ADDENDUM NO. 4

October 7, 2024

**South Westnedge School Remodel & Site Improvements
3333 South Westnedge Avenue
Kalamazoo, MI 49008**

This Addendum consists of Pages ADD 4-4 and attached TowerPinkster Addendum No. 4, dated October 4, 2024, consisting of 43 pages.

SHEET NUMBER
AD 101
23-606.00

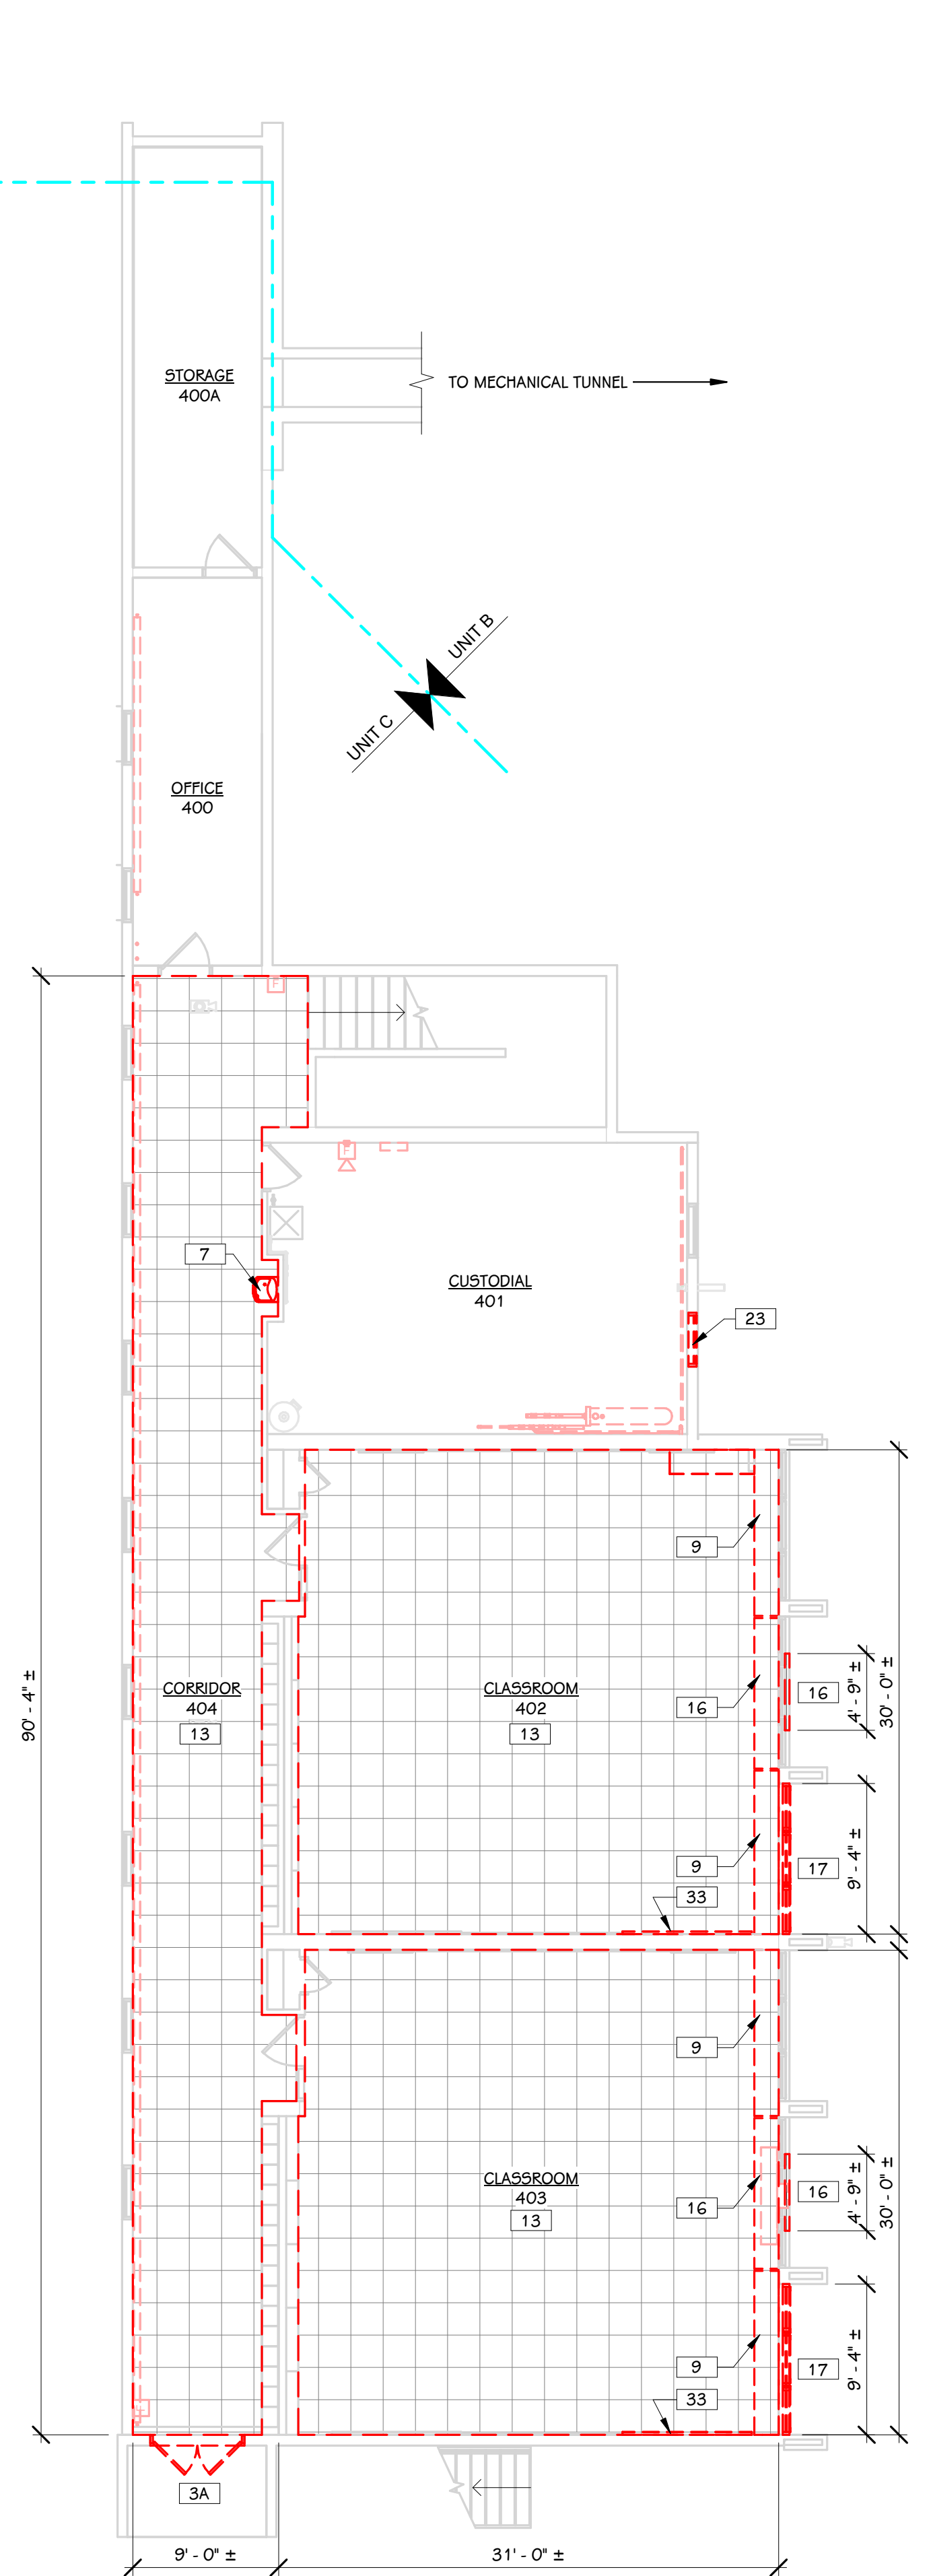
Refer to Sheet(s): AD 100A, AD 100B, AD 100C, AD 100D, AD 101, A 200, A 201C, A 201D

All ceilings in room previously designated as ceilings to be removed, salvaged and reinstalled ceilings are to be demolished and disposed of and new ceilings installed. Refer to revised drawings as listed above.

SHEET NUMBER
M 503
23-606.00

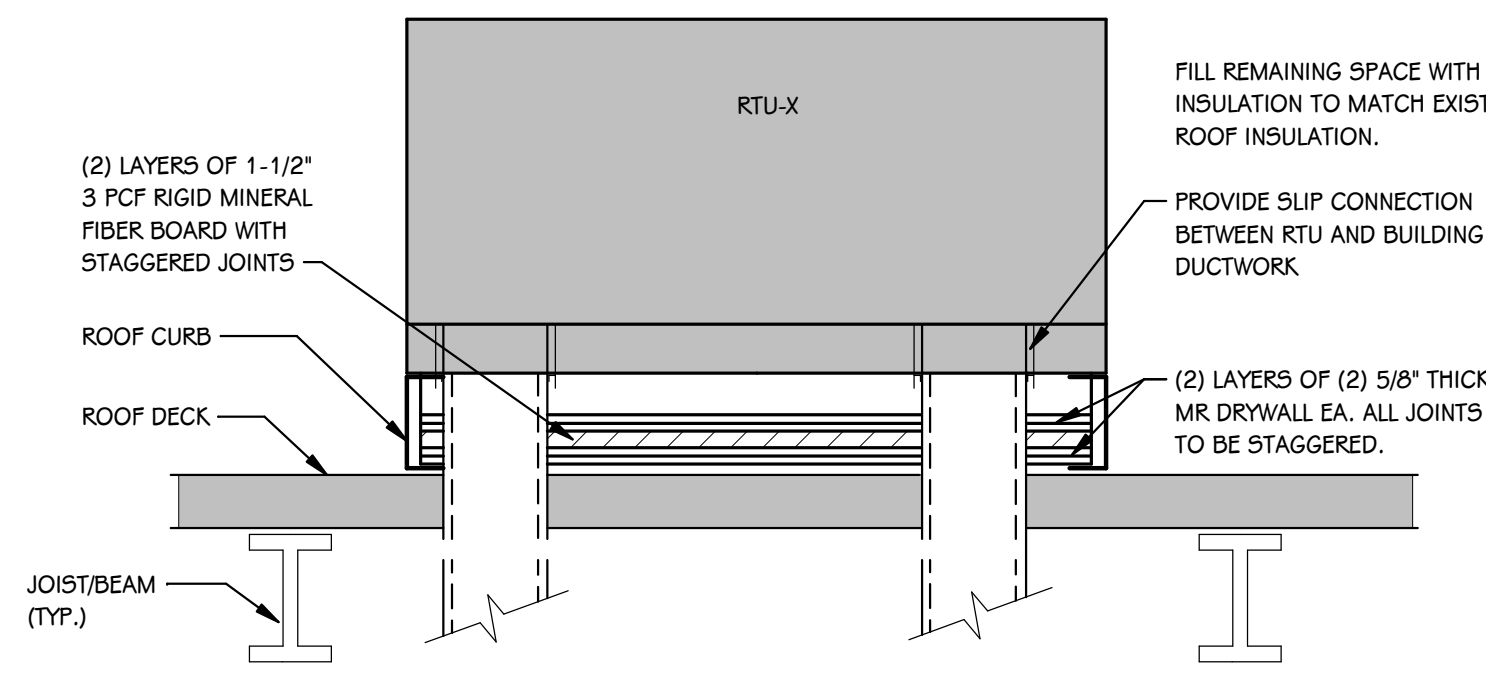
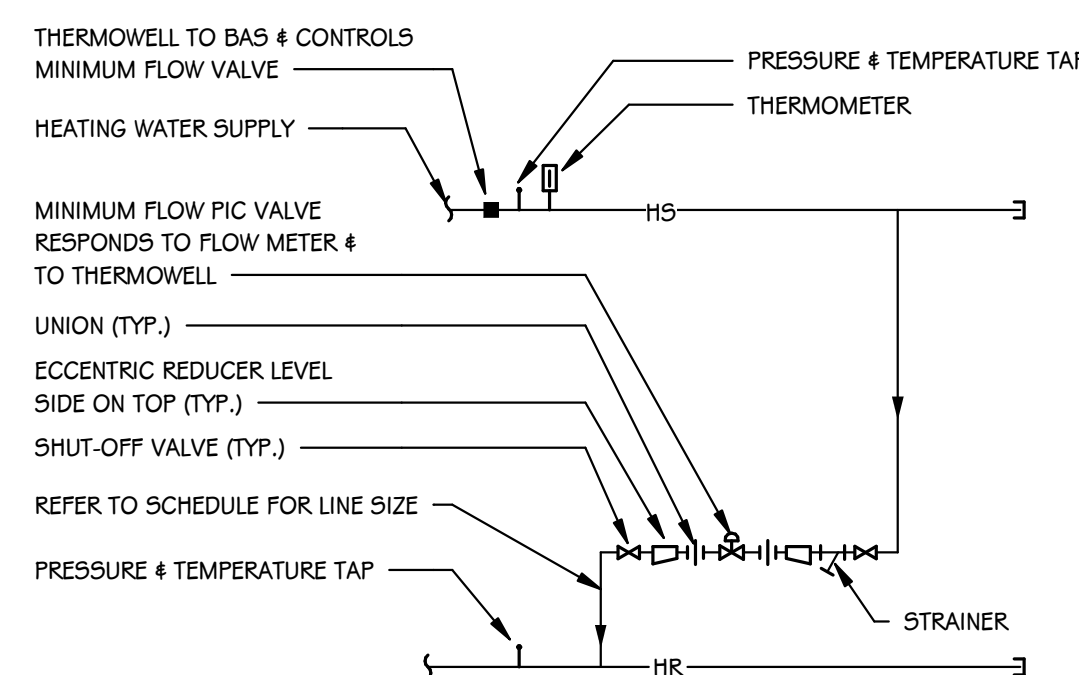
Refer to Sheet(s): M 201D, M503

Hydronic piping along east wall of gym modified to avoid structure. End of main bypass valve moved and upsized.

SHEET TITLE
ALTERNATES - FIRST FLOOR PLUMBING
PLAN - UNIT C

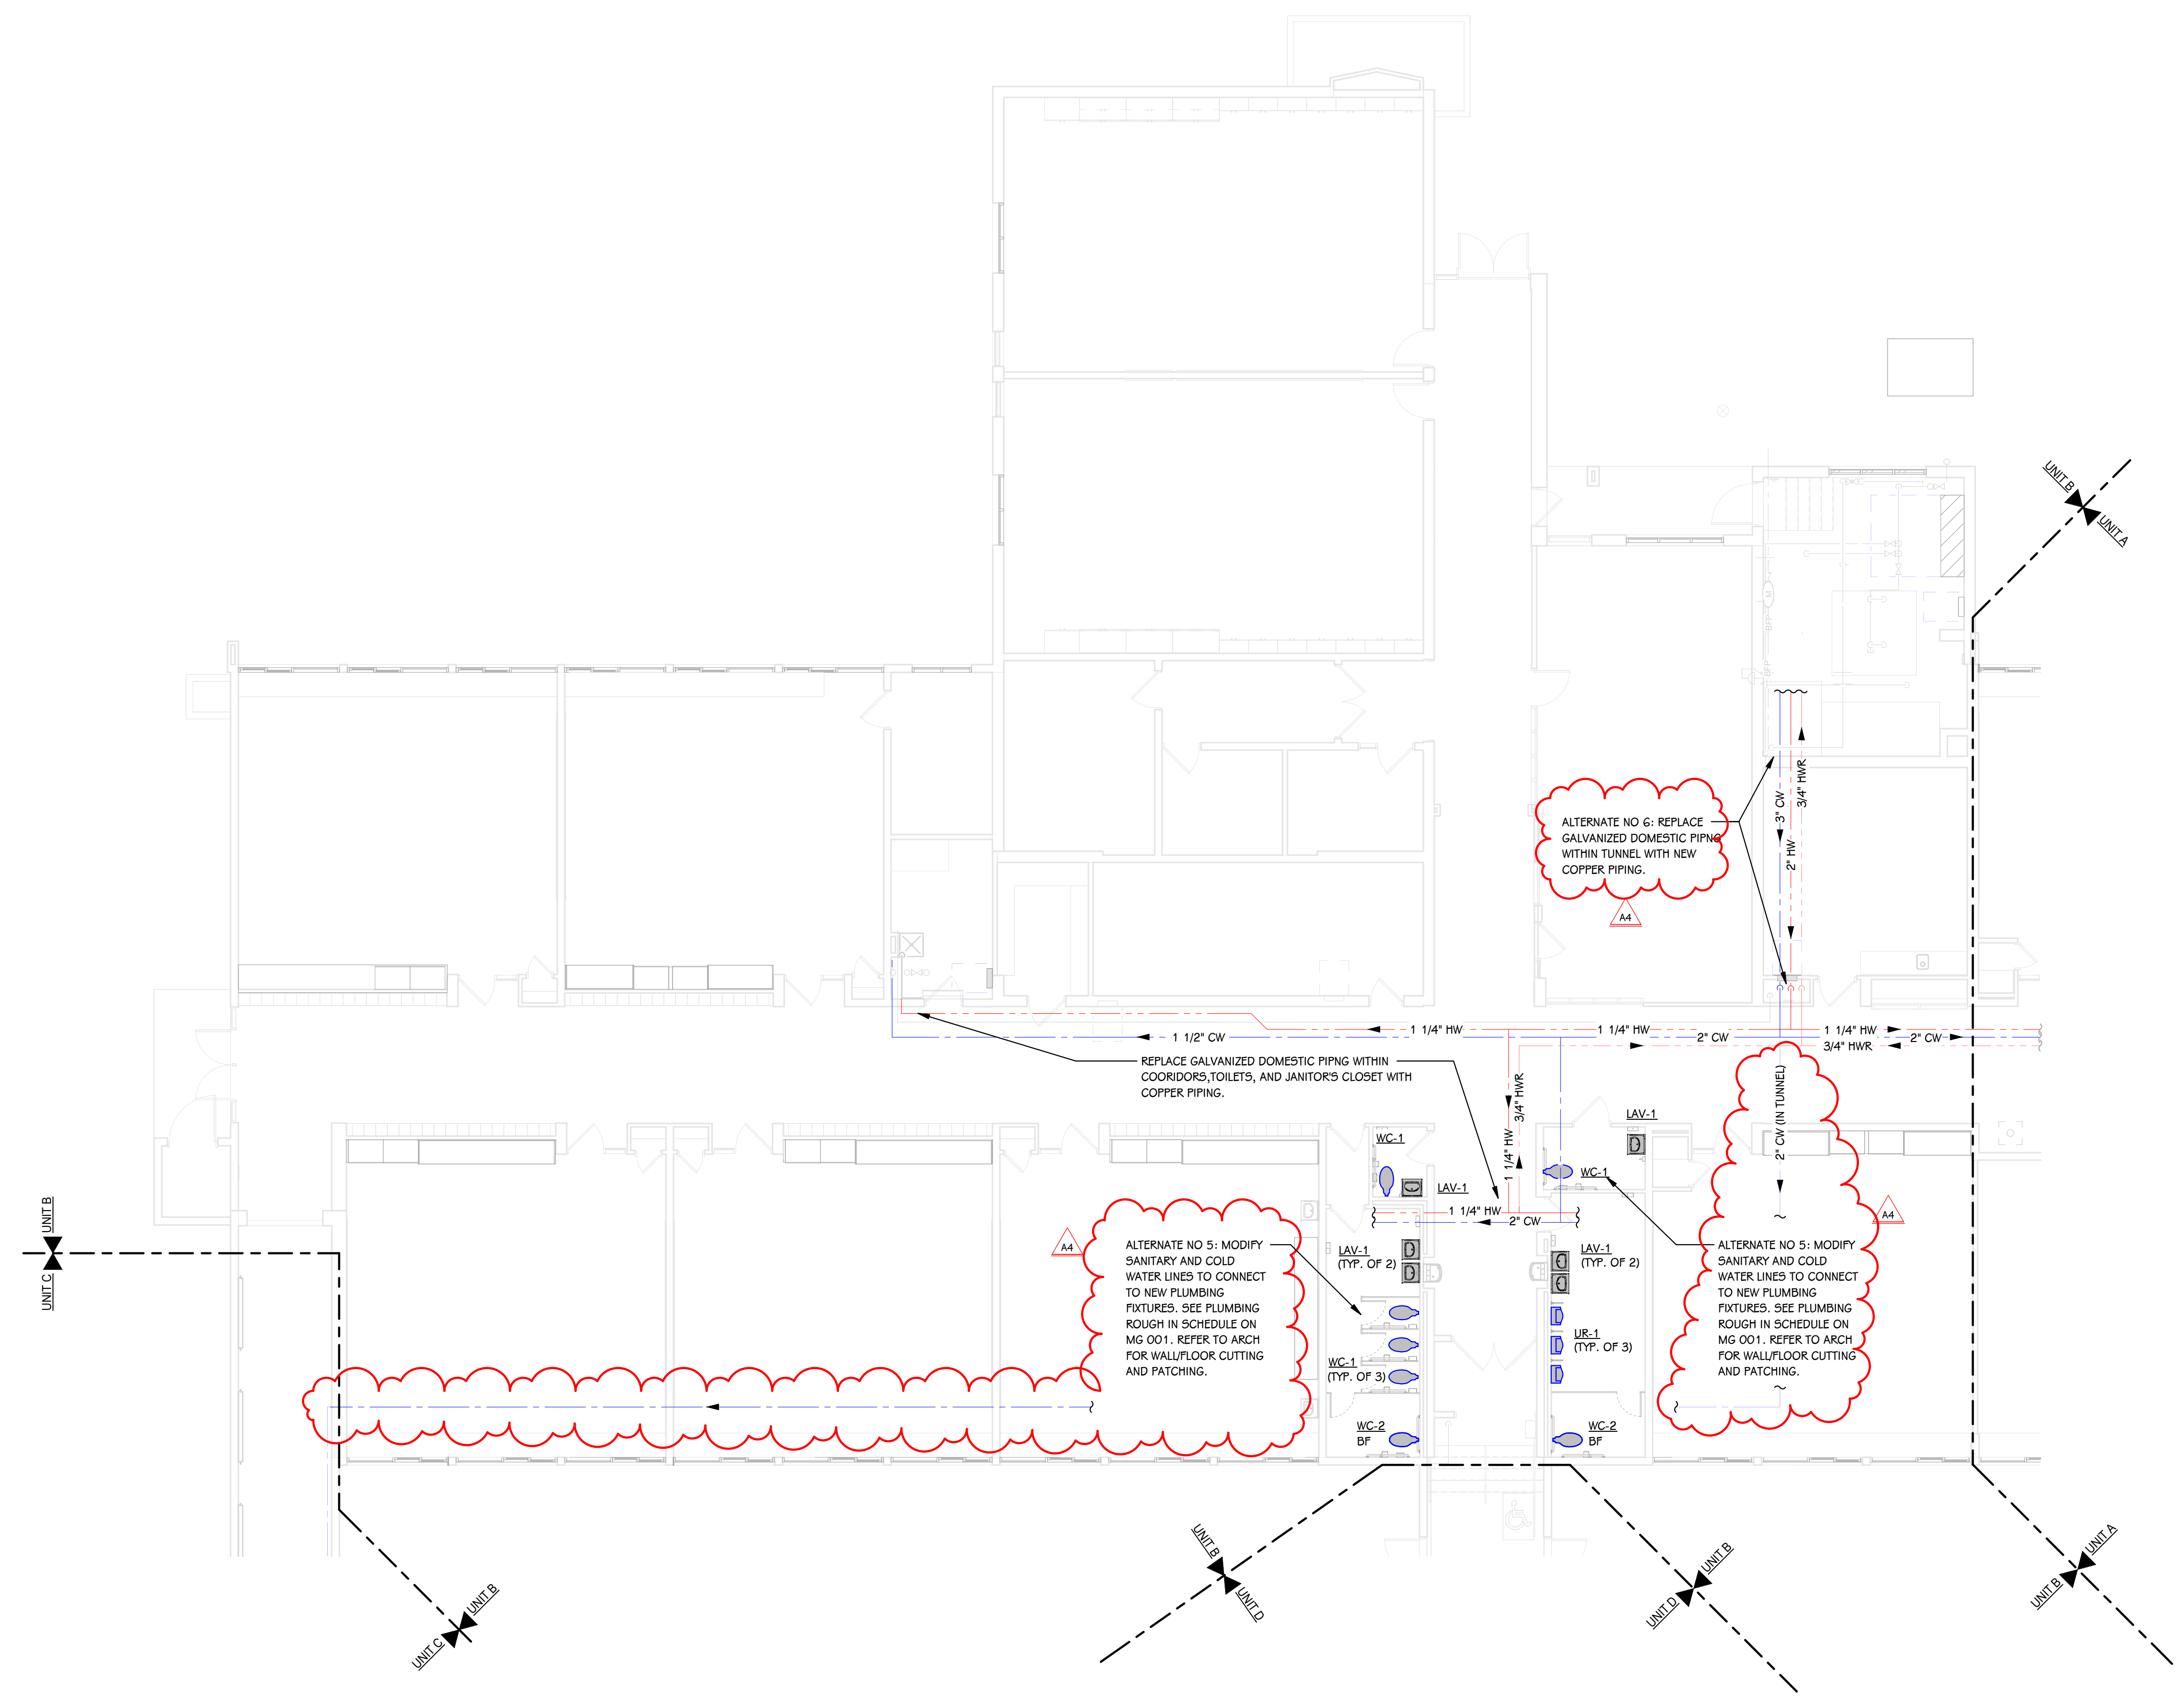
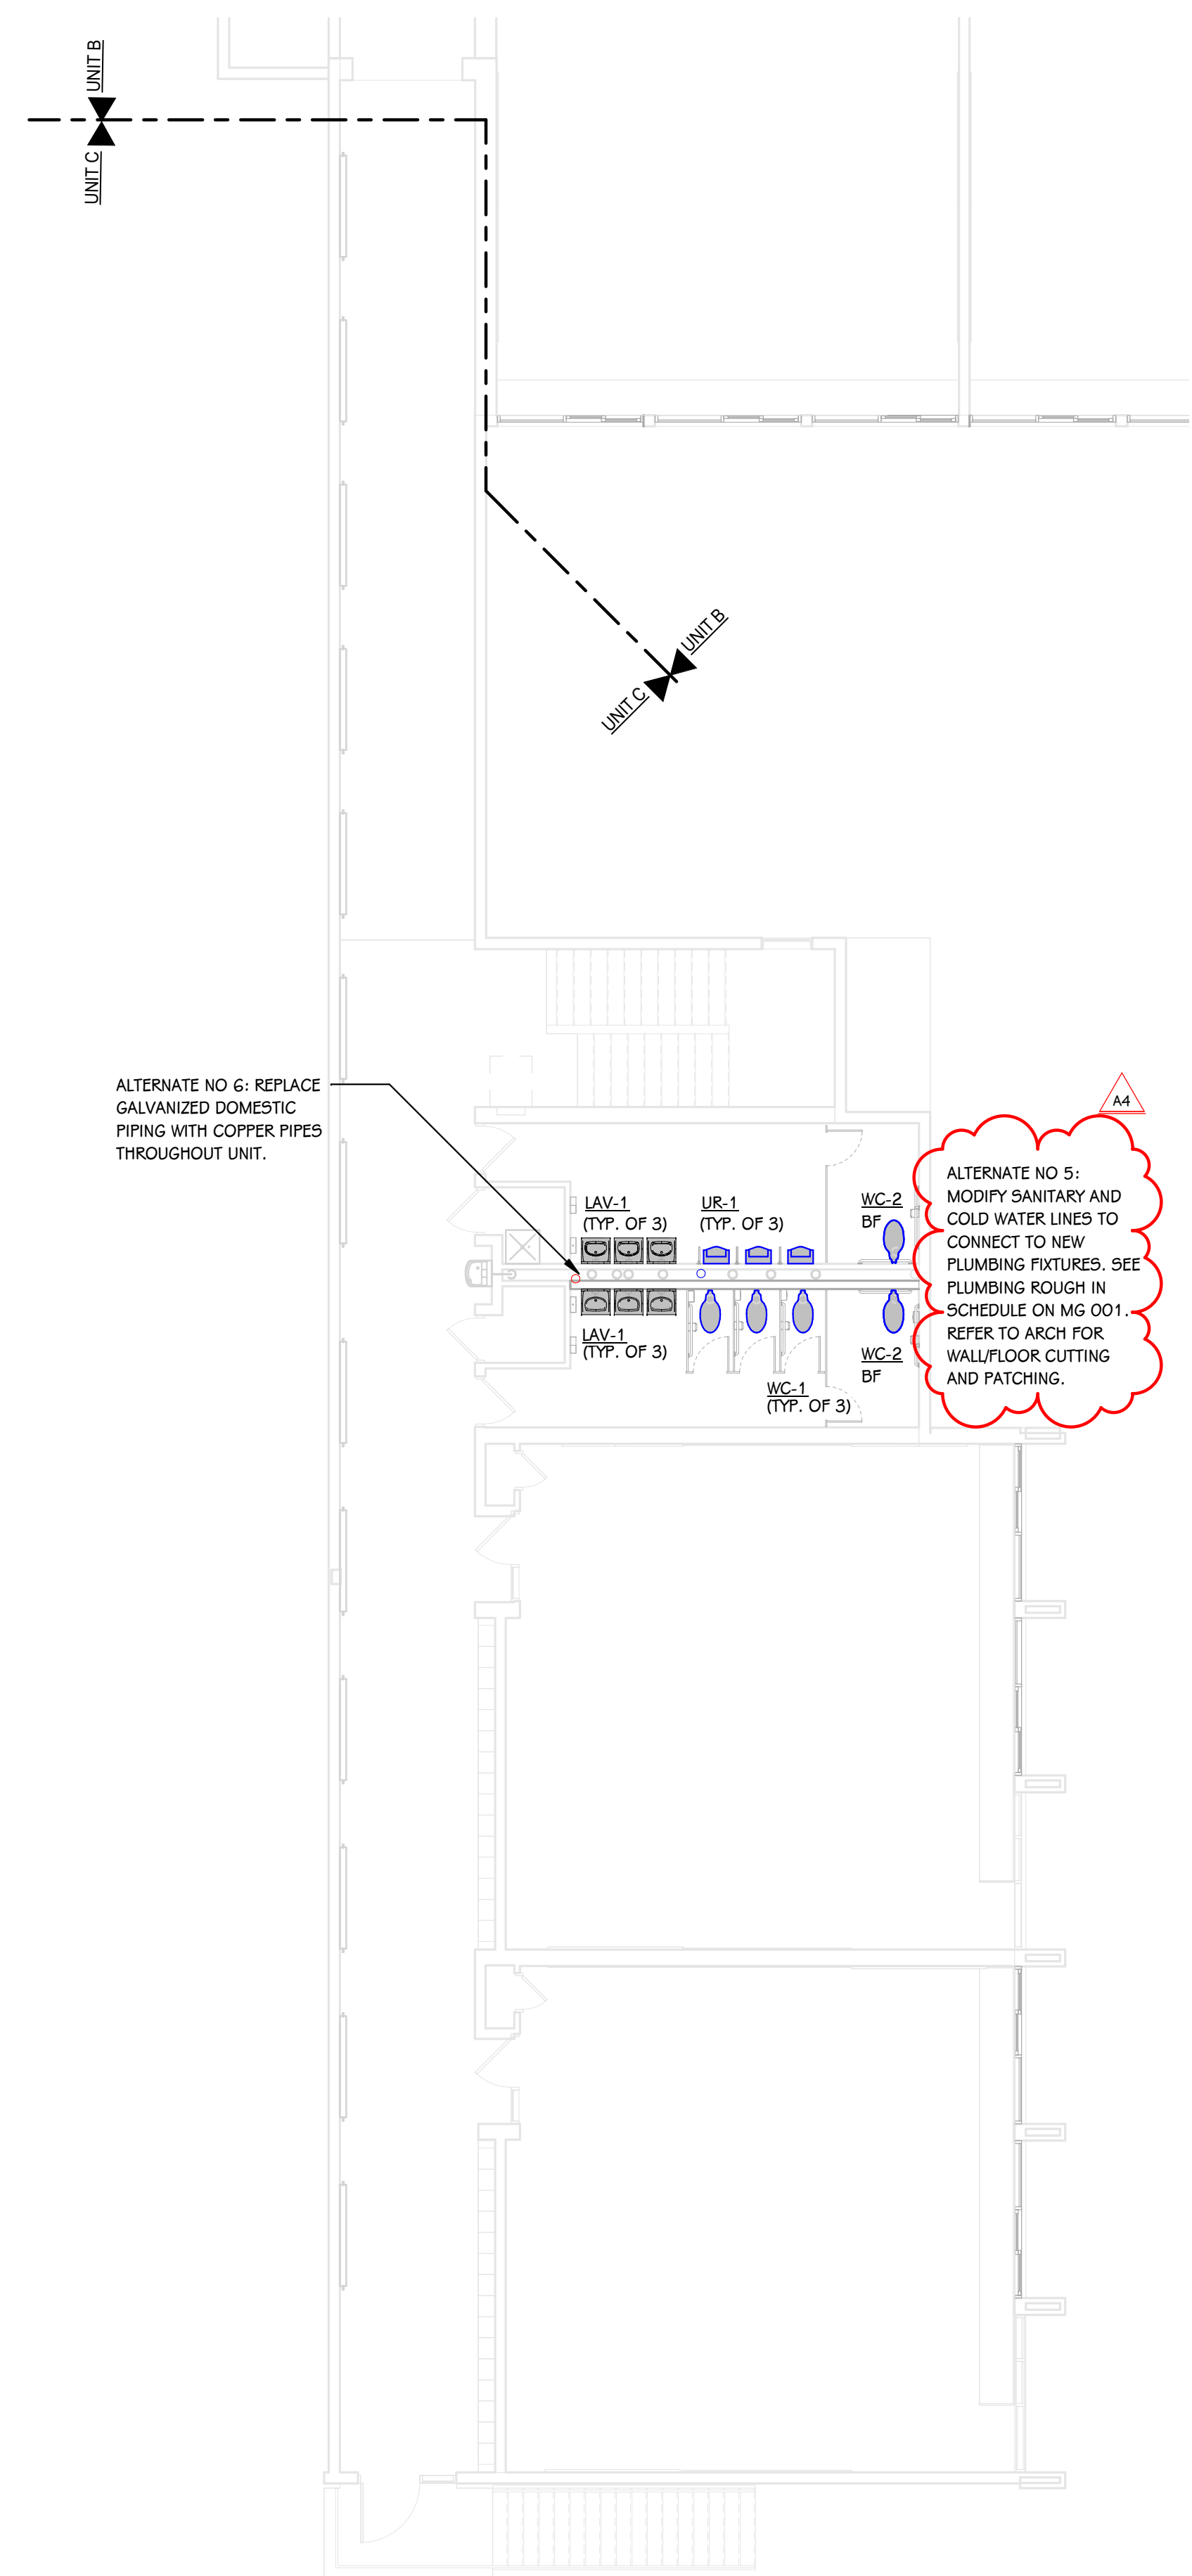
Refer to Sheet(s): P 801B, P801C, P 801D, PD 801A, PD 801B, PD 801C, PD 801D

Added demo sheets for the Alternates 5 & 6. Updated notes to provide clarity. Alternate 6 to replace all galvanized piping throughout units A, B, & C and within tunnels.
